## TECHNICAL BULLETIN

### NEW TROLLEY PLIERS

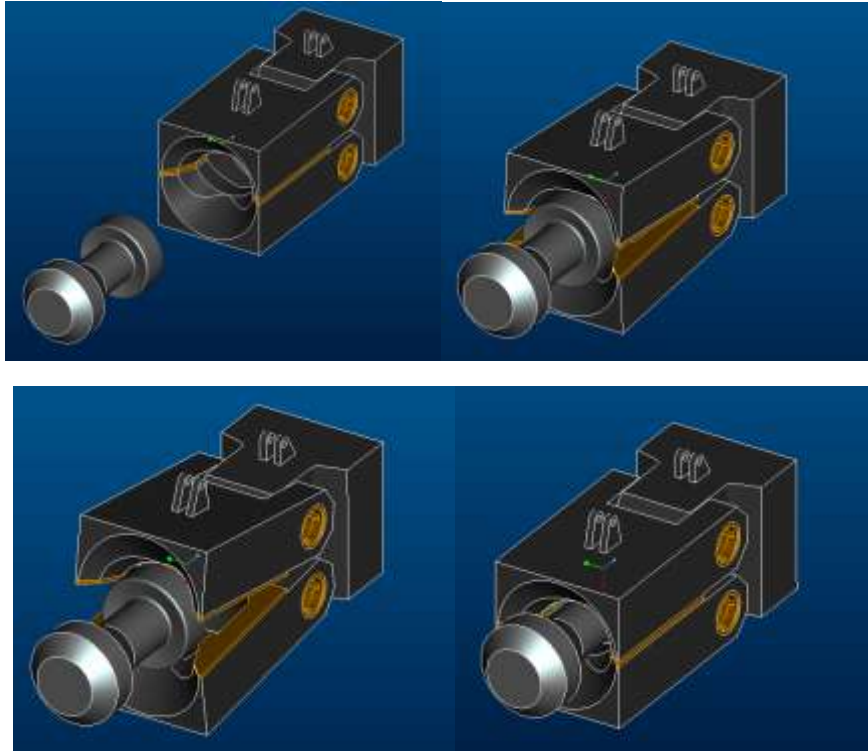
THE OLD TROLLEY PLIERS WERE REQUIRED TO BE OPENED BEFORE PIN ENGAGEMENT.

THE NEW TROLLEY PLIERS ALLOW THE BELL TO ENGAGE WITHOUT ANY OPENING COMMAND THANKS TO AN ADVANCED INTERNAL PROFILE, SHAPED AND TESTED IN DRASS LABORATORIES

THE REPLACEMENT DOES NOT REQUIRE ANY MODIFICATION TO THE OLED-DYNAMIC CIRCUIT.
